CHADBURN CONSERVATION ARCHITECT

Architects instruction

Employer: Bridgerule church PCC
 address: C/o Mr Trevor Bowden
 Churchtown Farm,
 Bridgerule,
 Holsworthy,
 Devon.
 Ex227EL
 A.I. no: **2020/13/AI01**

Works: Repointing of the church tower.
 Contract dated: 28th March 2025

St Bridget Church, Bridgerule - Tower south east pinnacle.

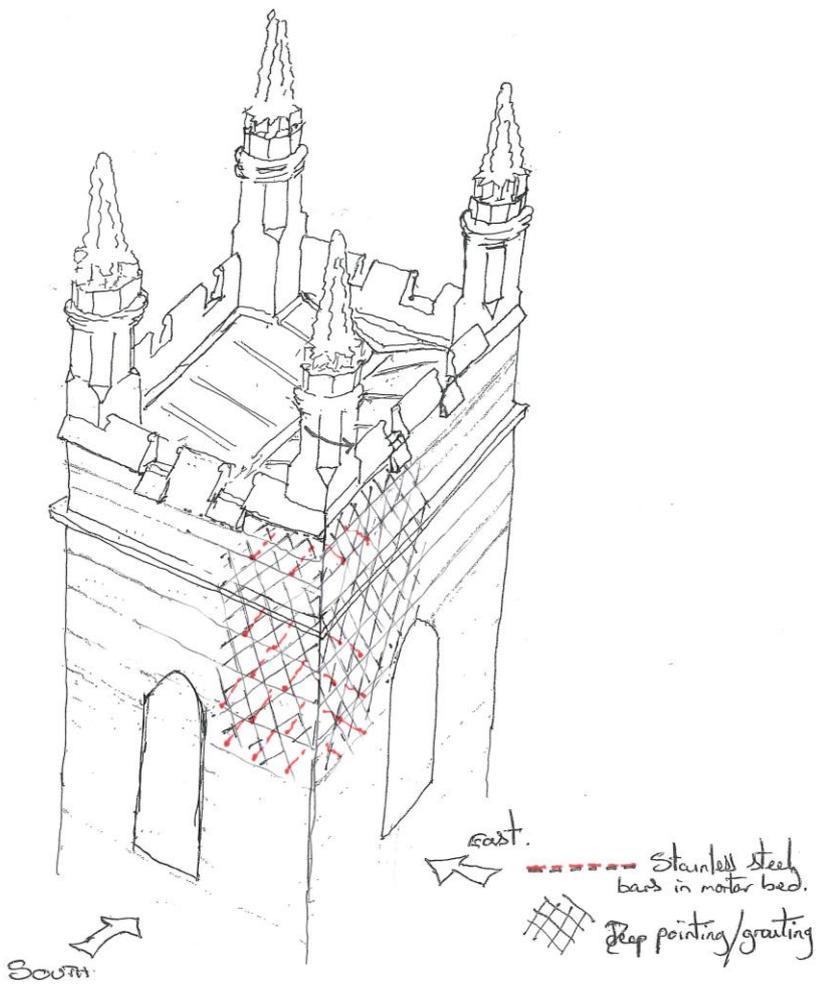
- We understand that the south eastern pinnacle was affected by a lightning strike in the middle part of C20 and that part of the pinnacle was rebuilt at this time together with associated repointing works.

- The pinnacle itself is inclined towards the south east although the upper pinnacle stones may have been reset to a degree to make them more vertical.

- From the evidence available, although there are a number of cracked and eroded cementitious mortar joints, there is no evidence of significant structural movement of the pinnacle since the works undertaken in the mid C20.

- It is evident that some delamination of the outer veneer of coarsed granite stones has occurred beneath the pinnacle shaft, also affecting the bell chamber window surround stones on the eastern elevation, which have move outwards slightly from the wall face.

- With respect to the pinnacle itself, the base stones of the upper tapered section of the pinnacle appear slightly displaced from the supporting stones, which may have occurred at the time of a lightning strike, but there is no evidence of further movement.

- We suggest 2 – 4/6mm diameter Heli-ties are introduced over the window height, on each side, to help secure the window surround stonework with the abutting walls. These should be inserted as generally discussed on site, positioned where wider stone joints allow.

- As outlined previously, we feel it would be sensible to pin the outer veneer of granite stones back to the core and inner stonework; this applies to the base of the pinnacle shaft and over the upper part of the bell chamber, beneath the pinnacle.

- During the repointing process, it should be possible to pin the base tapered stones to the stone course beneath, providing better connection at the base of the pinnacle.

- As discussed, it is important that the joints are very well repointed to a minimum depth of 50mm or 60mm, together with localised cavities and voids filled in and well packed, all as discussed on site.

Suggested repair.
 13/2020/SK01 - 10.07.25

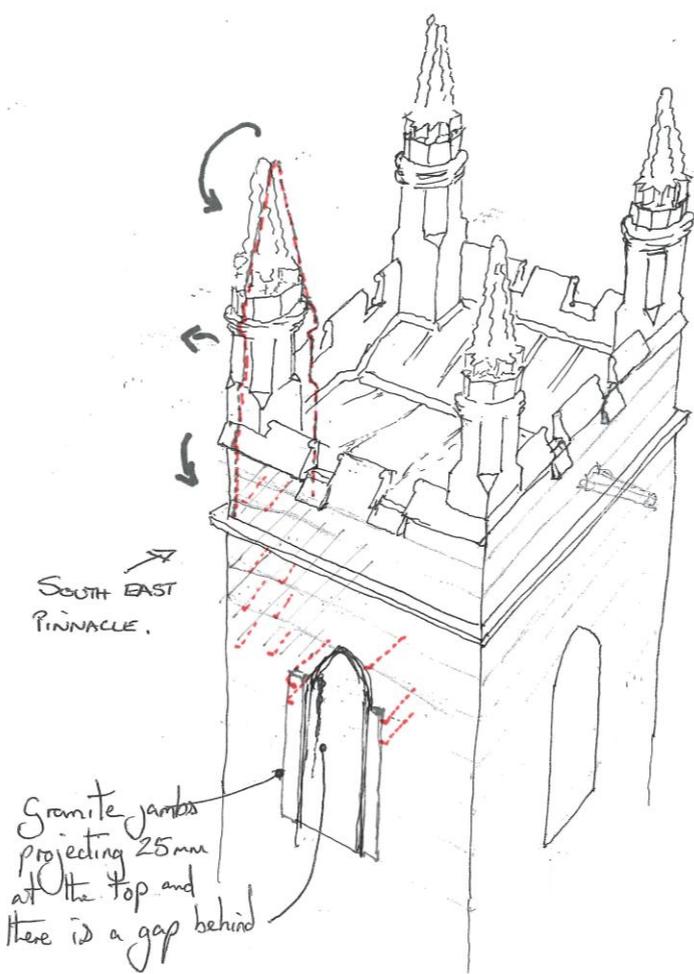
OBSERVED MOVEMENT.

--- 4-6mm STAINLESS STEEL HELIFIX RODS 300mm LONG
